ADDENDUM NUMBER FOUR (4)

BASEBALL PAVILION REPAIRS
MISSISSIPPI VALLEY STATE UNIVERSITY
ITTA BENA, MISSISSIPPI

Addendum No. 4
Baseball Pavilion Repairs
Mississippi Valley State University
DDG Project No.: 20.012

1 **INTERIOR ELEVATION**
 SUP06 1/4" = 1'-0"

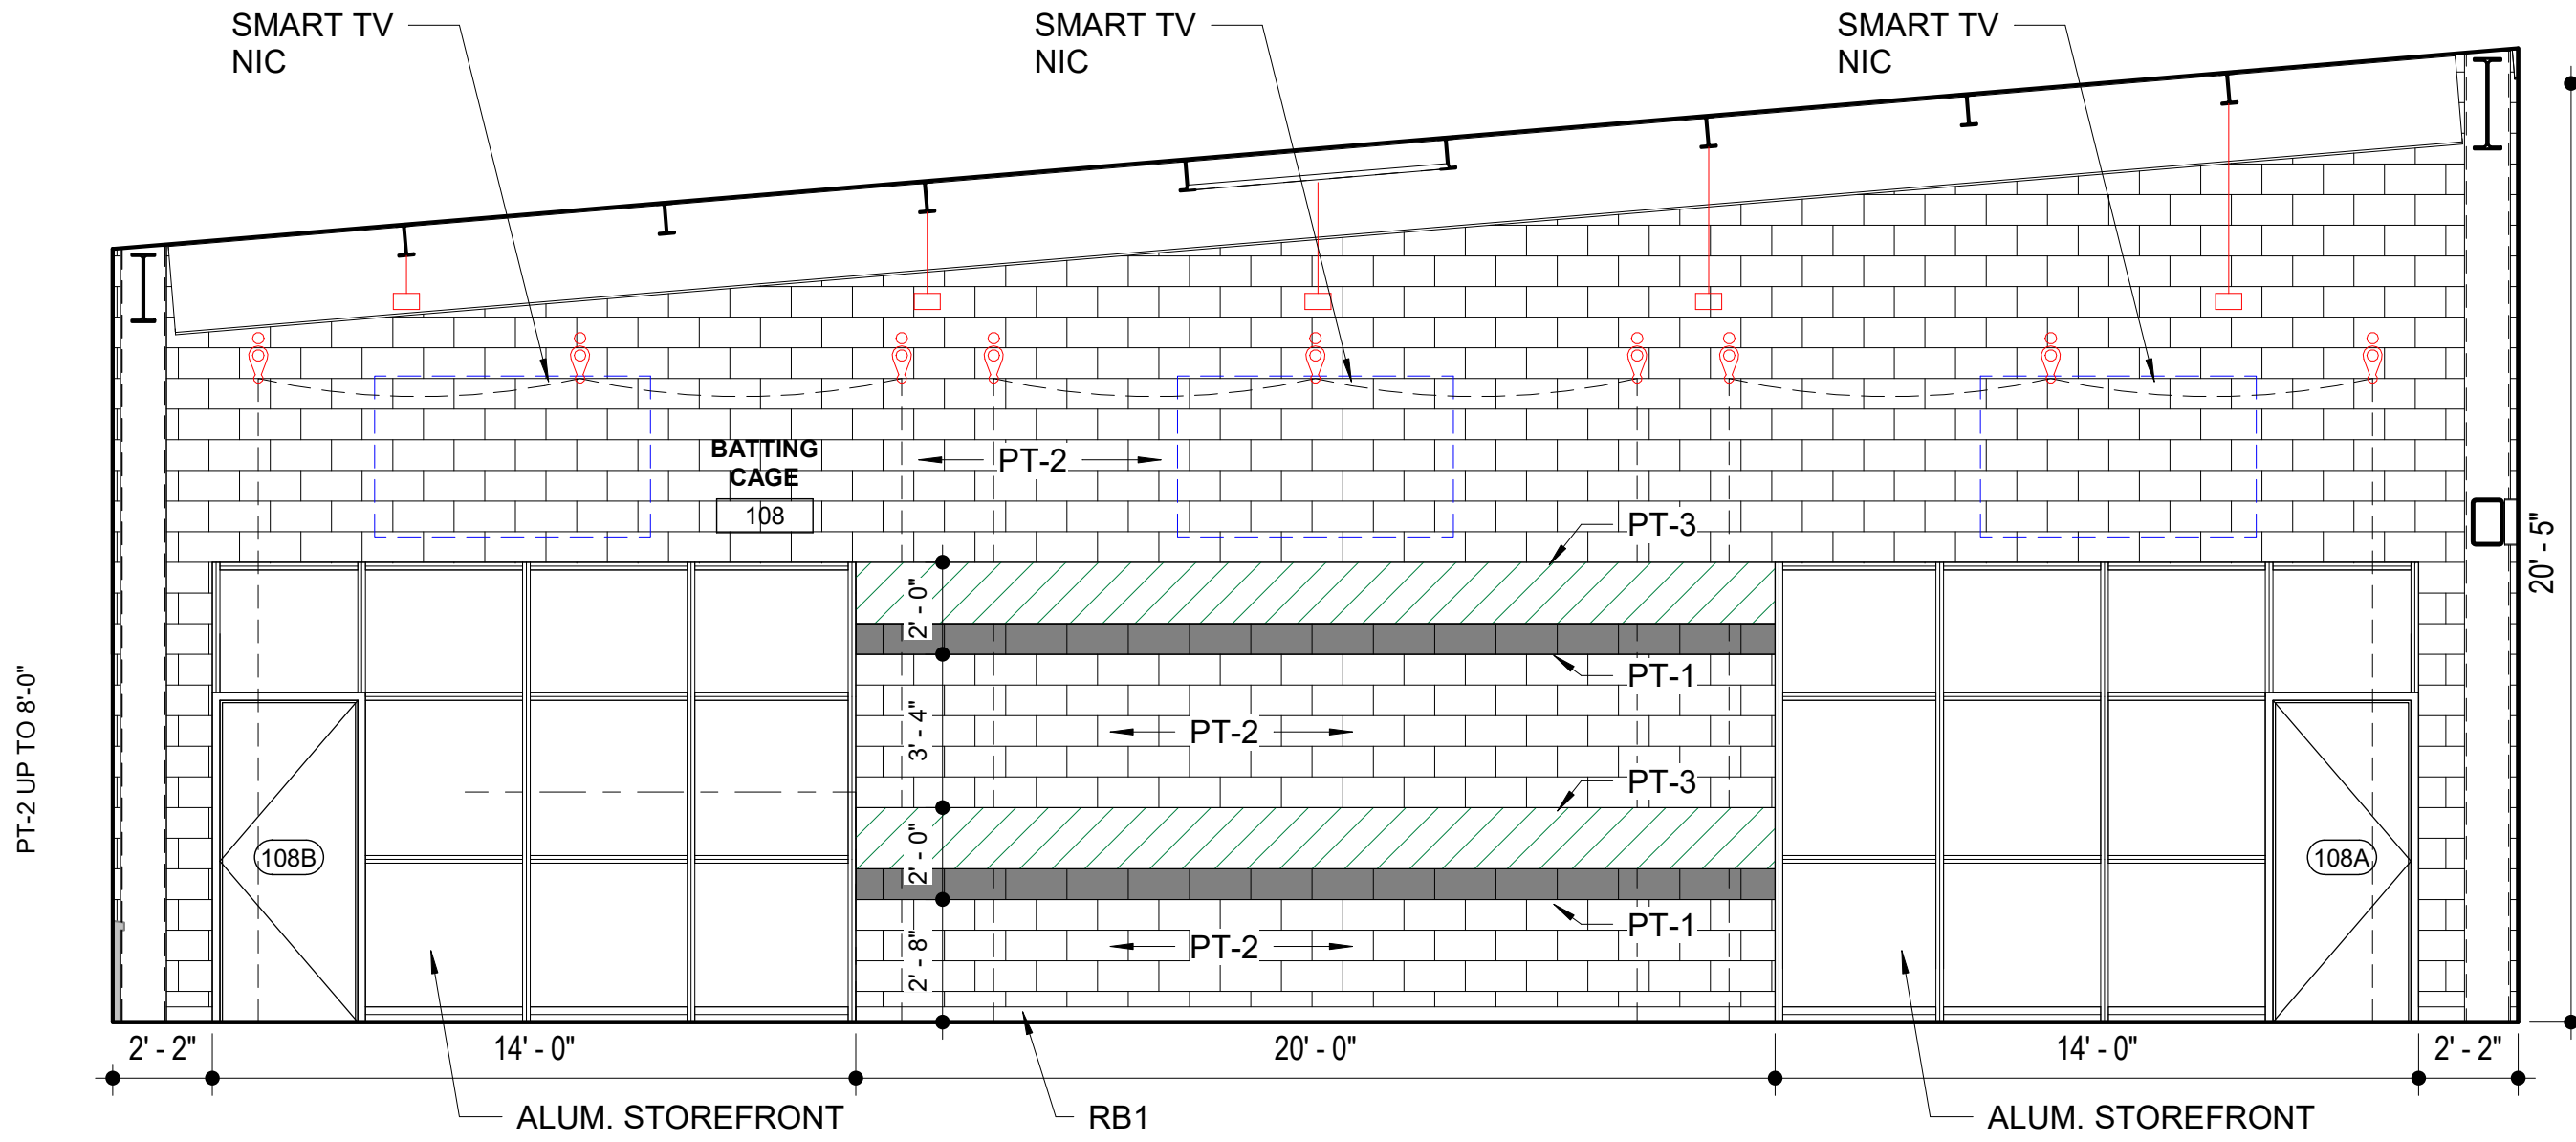
1. **DELETE** Drawing 3, 4, 6, AND 7 IN SHEETA702B and **REPLACE** with Attached SUP05.
2. **DELETE** Drawing 5 IN SHEETA702B and **REPLACE** with Attached SUP06.
